Los Angeles Regional Water Quality Control Board

SUBJECT: REVIEW OF REVISED EVALUATE NEED FOR ACTION ZONE PLAN, PURSUANT TO CALIFORNIA WATER CODE SECTION 13304 CLEANUP AND ABATEMENT ORDER NO. R4-2021-0079

SITE: SKYPARK COMMERCIAL PROPERTIES (ASSESSOR PARCEL NO. 7377-006-906), 24701 – 24777 CRENSHAW BOULEVARD AND 2530, 2540, AND 2600 SKYPARK DRIVE, TORRANCE, CALIFORNIA (SCP NO. 1499)

SUBJECT: REVIEW OF RESPONSE TO COMMENTS – DECISION FLOW CHARTS AND ENA ZONE PLAN PURSUANT TO CALIFORNIA WATER CODE SECTION 13267

Attachment 2 - Figure 6 – Soil Vapor Sampling Results

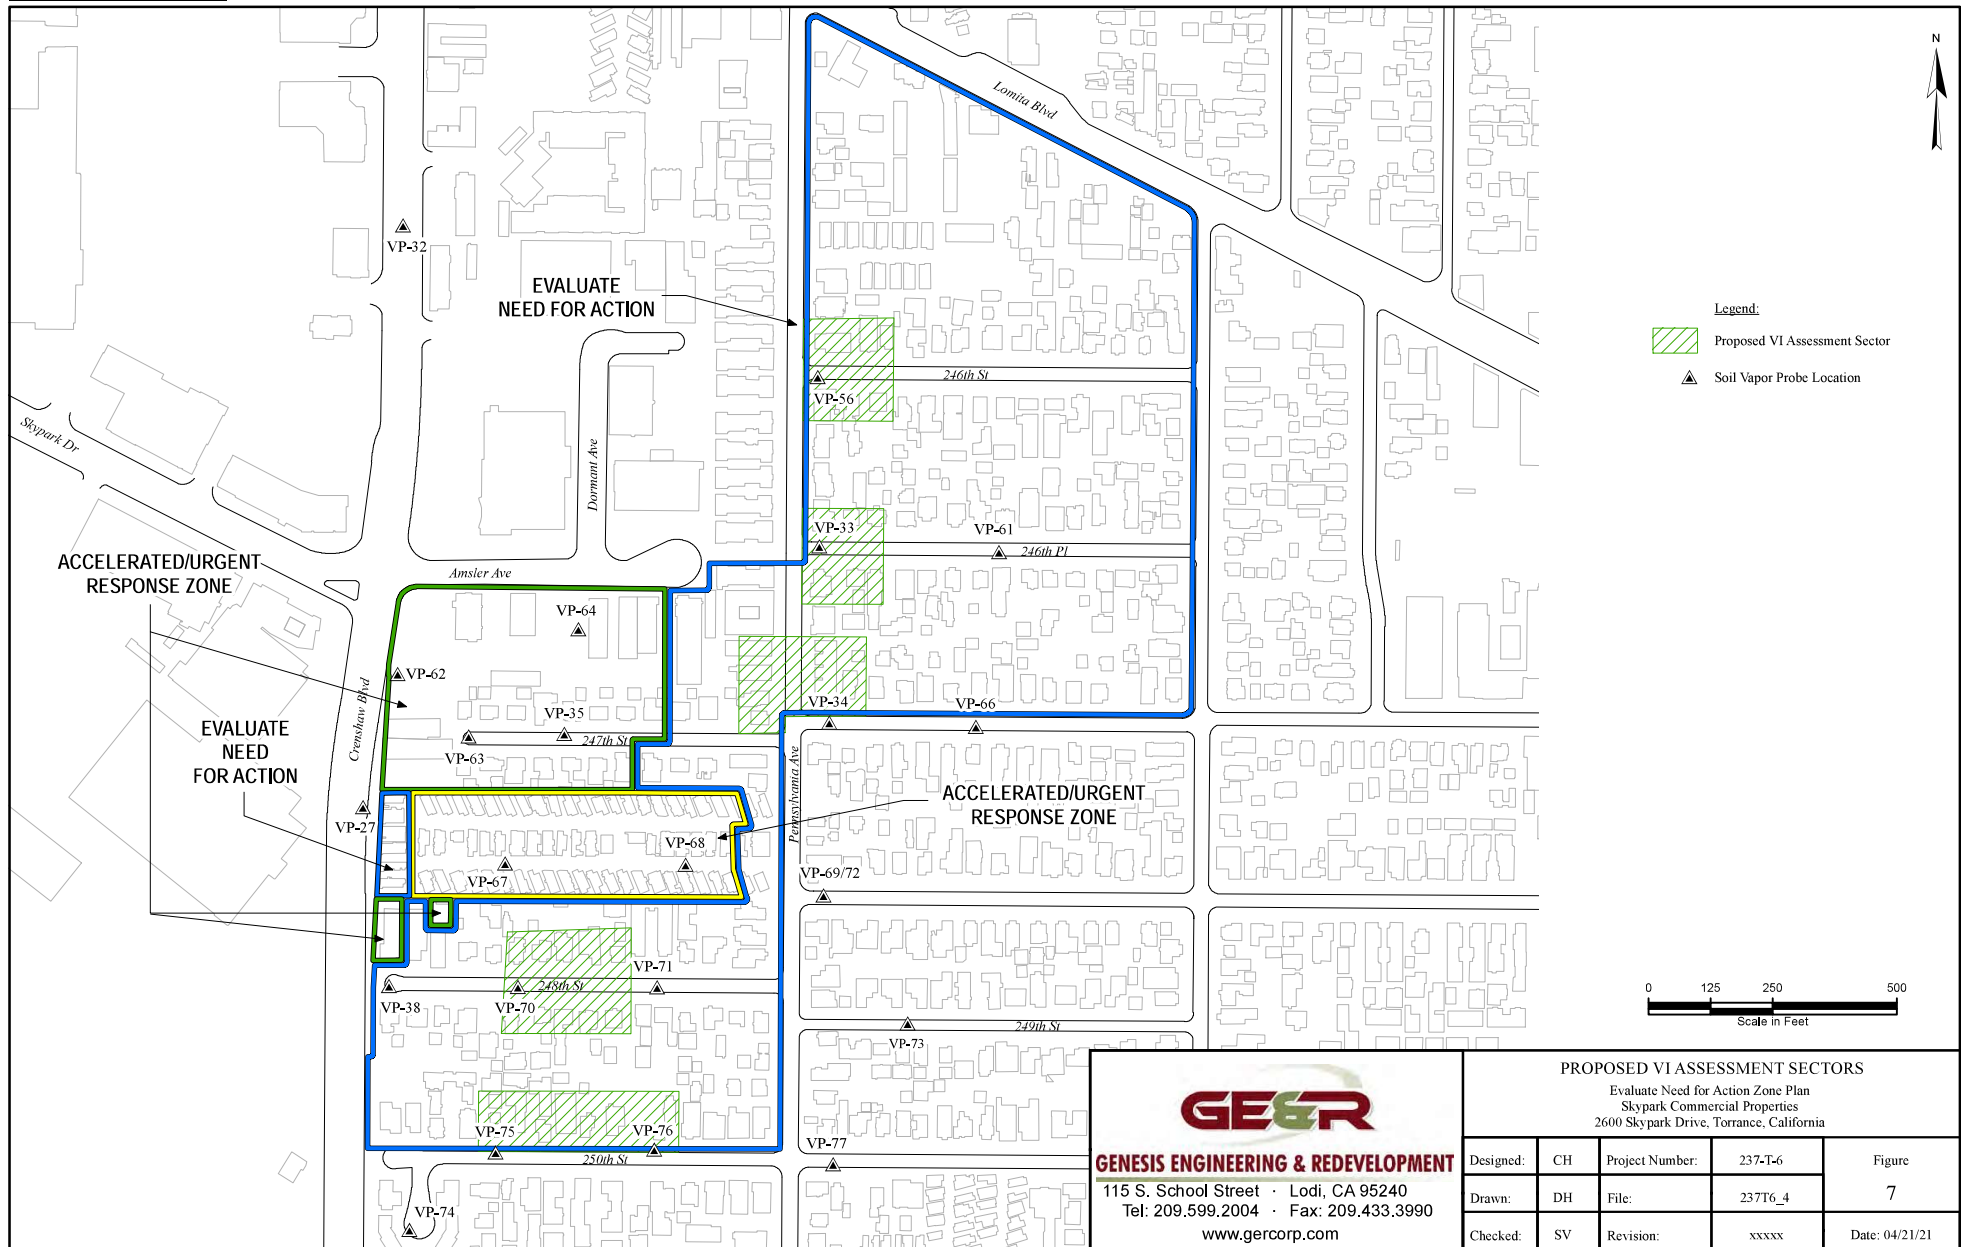
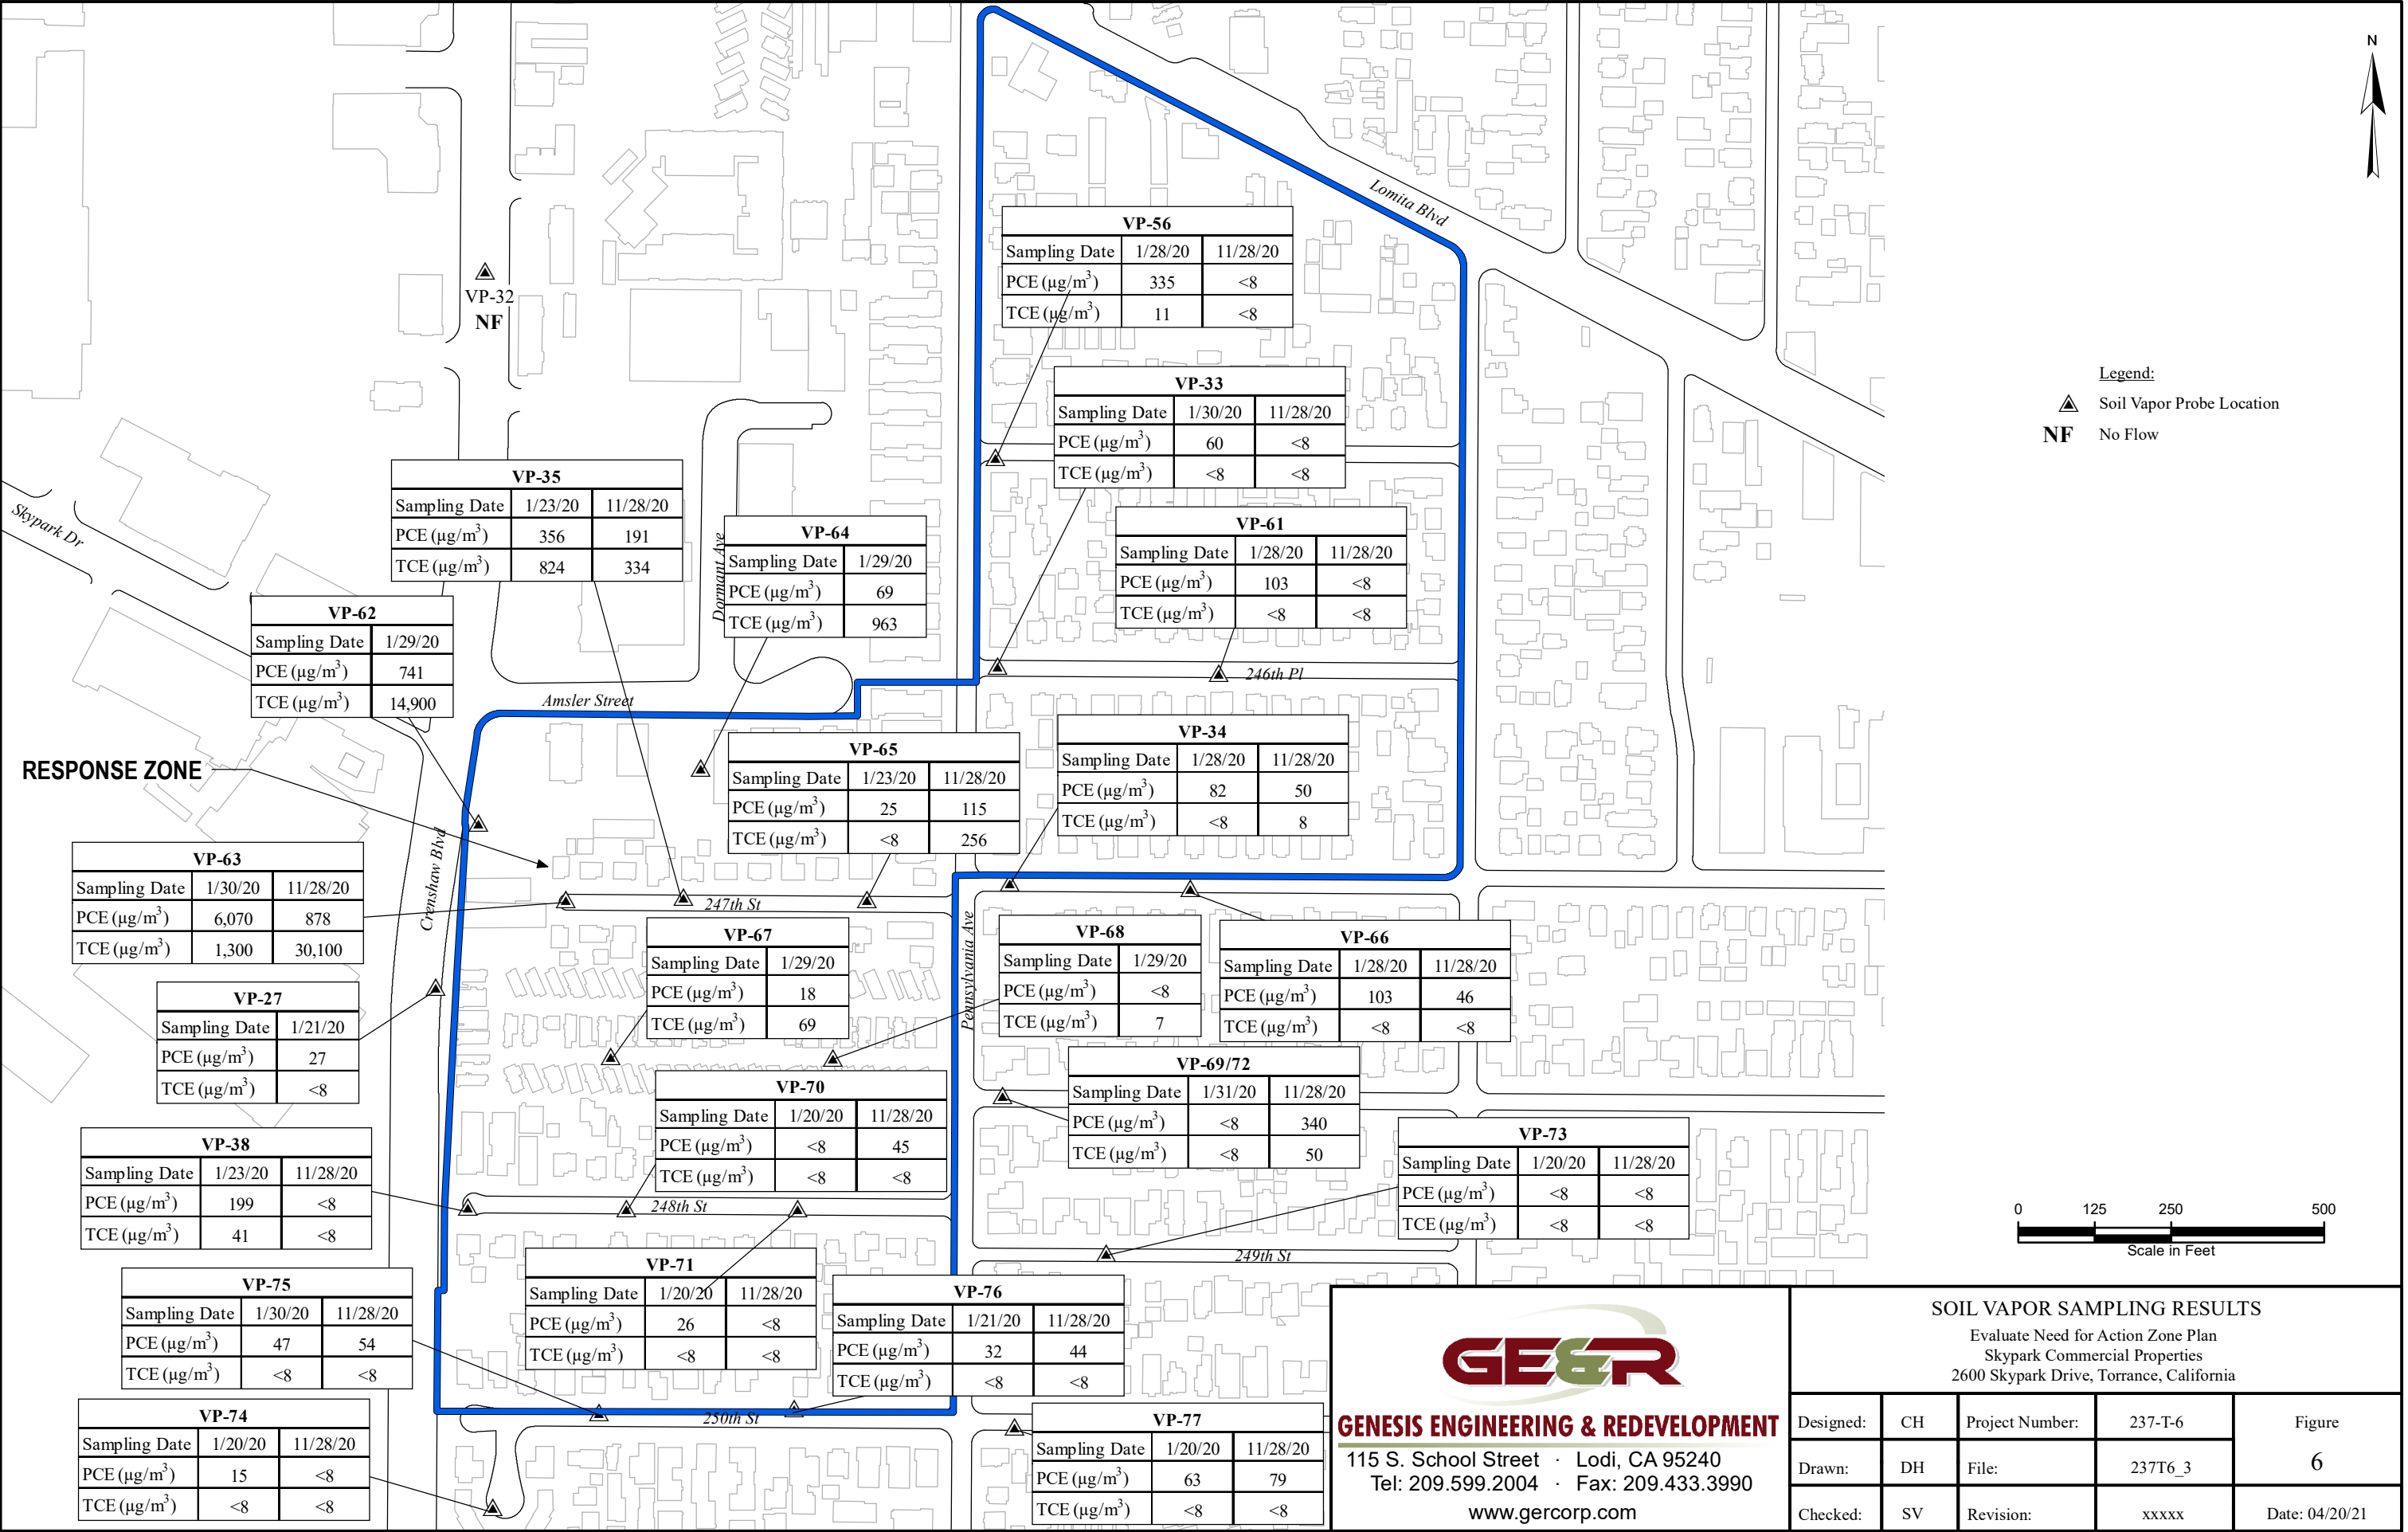
1. Designate five sectors defined by nearby soil vapor concentrations from probes in public rights of way. The sectors are located near soil vapor probe locations: VP-33, VP-34, VP-56, VP-70 and VP-71, and VP-75 and VP-76 (see attached figures 6 and 7). Each sector encompasses approximately 6 to 10 properties.

- i. VP-66 – in the last two sampling events, soil vapor PCE concentrations exceeded its residential screening level at 5 ft-bgs (103 micrograms per cubic meter [$\mu\text{g}/\text{m}^3$] on January 28, 2020 and $46 \mu\text{g}/\text{m}^3$ on November 28, 2020) and 15 ft-bgs ($126 \mu\text{g}/\text{m}^3$ on January 28, 2020).

- ii. VP-69/72 – in the most recent sampling event, soil vapor PCE and TCE concentrations exceeded their residential screening levels at 5 ft-bgs ($136 \mu\text{g}/\text{m}^3$ of PCE and $50 \mu\text{g}/\text{m}^3$ of TCE).

- iii. VP-77 – in the last two sampling events, soil vapor PCE concentrations exceeded its residential screening level at 5 ft-bgs ($63 \mu\text{g}/\text{m}^3$ on January 20, 2020 and $79 \mu\text{g}/\text{m}^3$ on November 28, 2020).

Attachment 3 - Figure 7 – Proposed VI Assessment Sectors

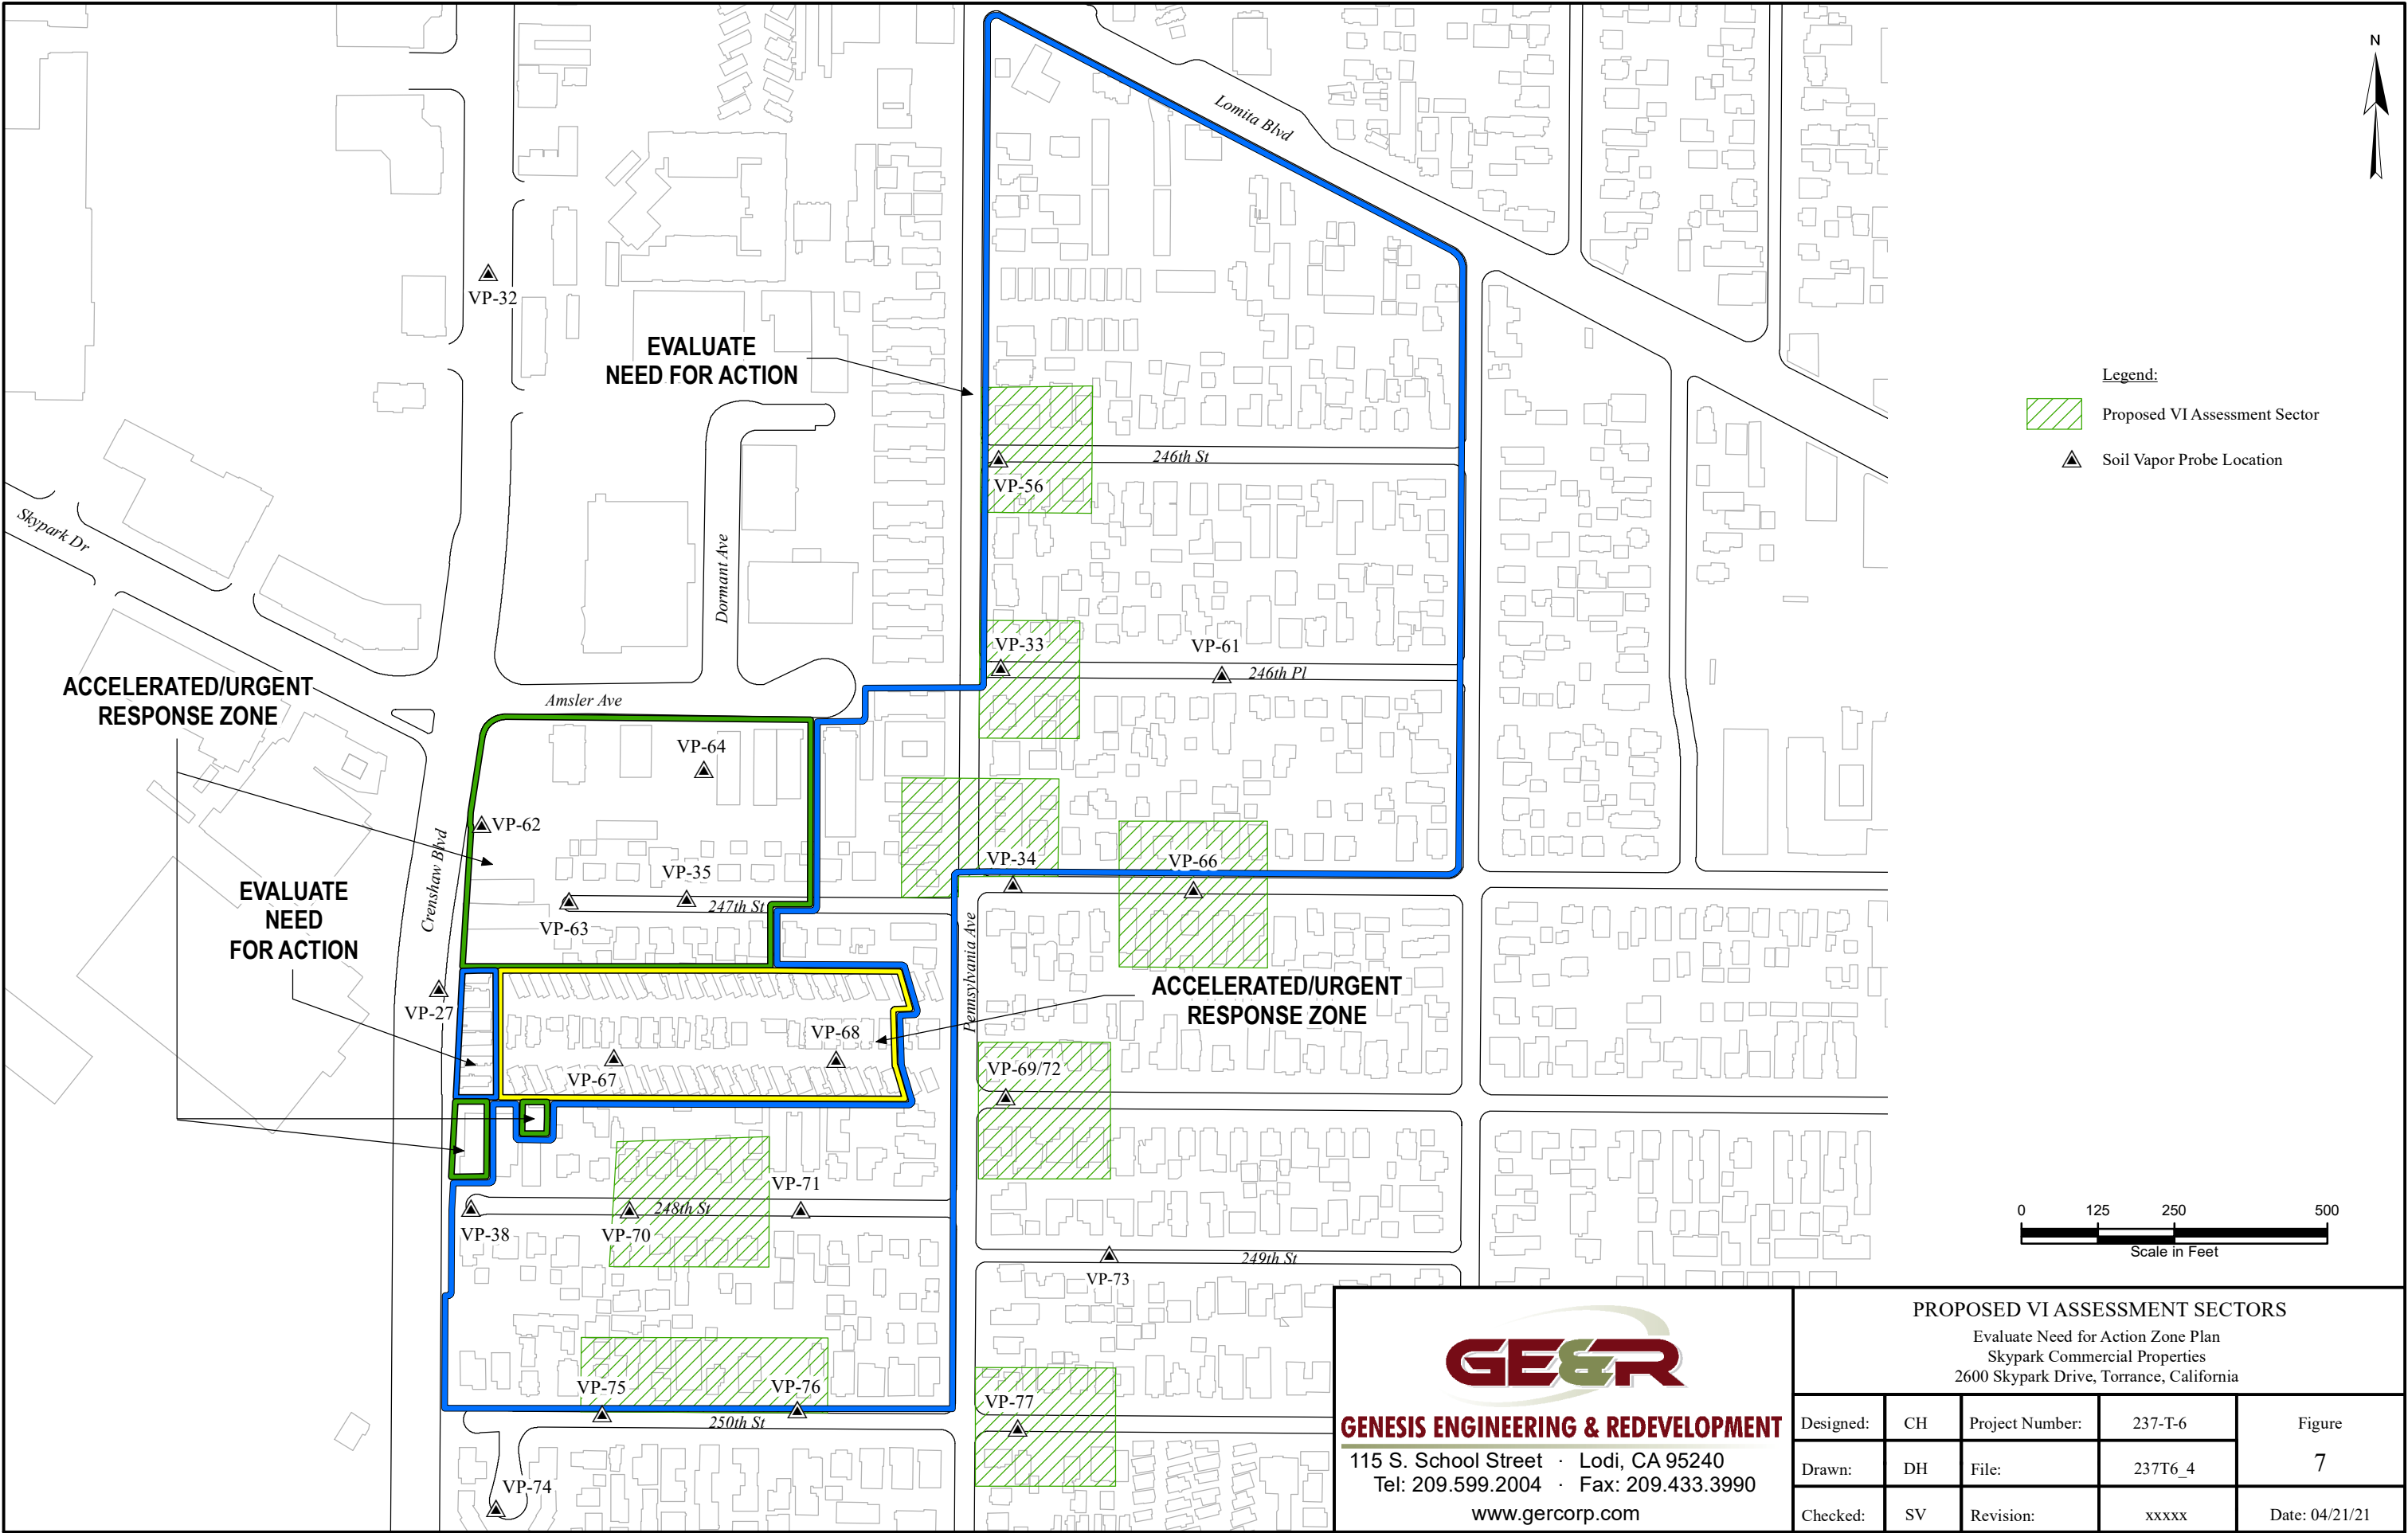
1. Designate eight sectors defined by nearby soil vapor concentrations from probes in public rights of way. The sectors are located near soil vapor probe locations: VP-33, VP-34, VP-56, VP-66, VP-69/72, VP-70 and VP-71, VP-75 and VP-76, and VP-77 (see attached Figures 6 and 7). Each sector encompasses approximately 6 to 10 properties.

3. Based on available soil vapor data to date, the following modifications shall be made to the ENA Zone Plan:
 - a. Additional sectors shall be designated near the following soil vapor probe locations:

- b. The sector addressing soil vapor probe locations VP-75 and VP-76 shall be extended to include properties to the south and across 250th Street.
 - c. The sector addressing soil vapor probe location VP-34 shall be extended to include properties located at the southeast corner of the Pennsylvania Avenue and 247th Street intersection.

8. The Regional Water Board generally concurs with GER’s stepwise approach in prioritization and representative sampling of the ENA Zone.
9. Revise the ENA Zone Plan and Figure 7 – Proposed VI Assessment Sectors to reflect items 2 through 7 above and resubmit it to the Regional Water Board by **August 13, 2021**.
